Isolation Rewrite Proposal

IEEE P802.3da 10 Mb/s Single Pair Multidrop

2025-03-11

“Electrical distribution system types”

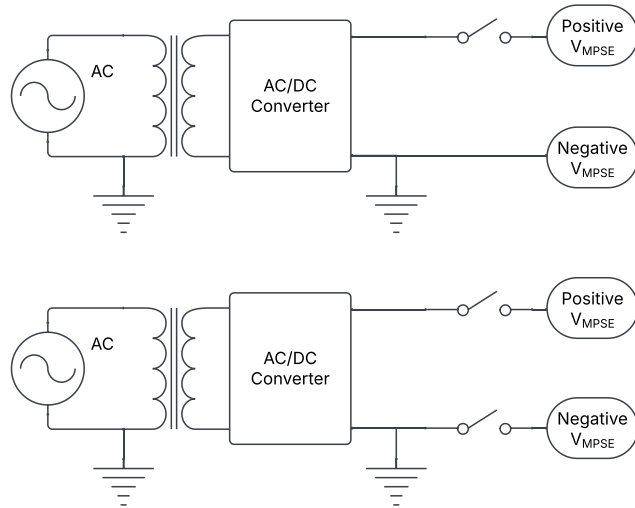
Isolated MPoE power distribution system: A mixing segment that crosses ground references, the boundary between separate power distribution systems, or the boundaries of a single building.

Grounded MPoE power distribution system: When a mixing segment, with all its associated interconnected equipment, shares a common, continuous ground.

Justification: In PoE, the meaning of Environments A & B was hidden behind a letter designator, was rarely referenced and was often ignored. Let’s say what we mean using familiar terms!

Grounding Requirements

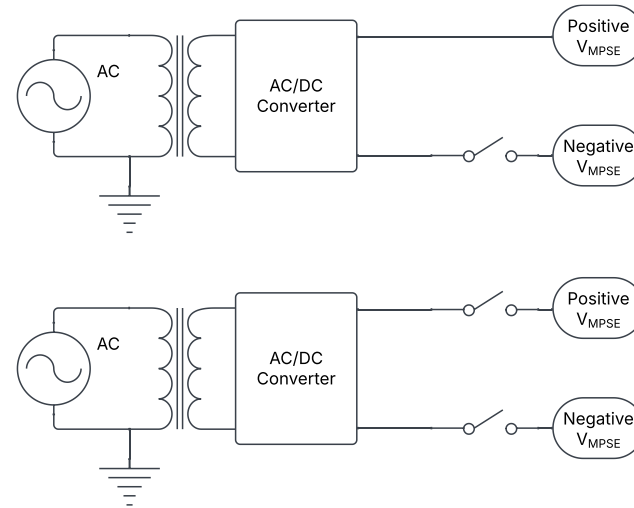
Grounded MPoE power distribution system

Isolated MPoE power distribution system

Note: Grounded MPoE MPSEs and MPDs *shall be labeled* to indicate they are **grounded**
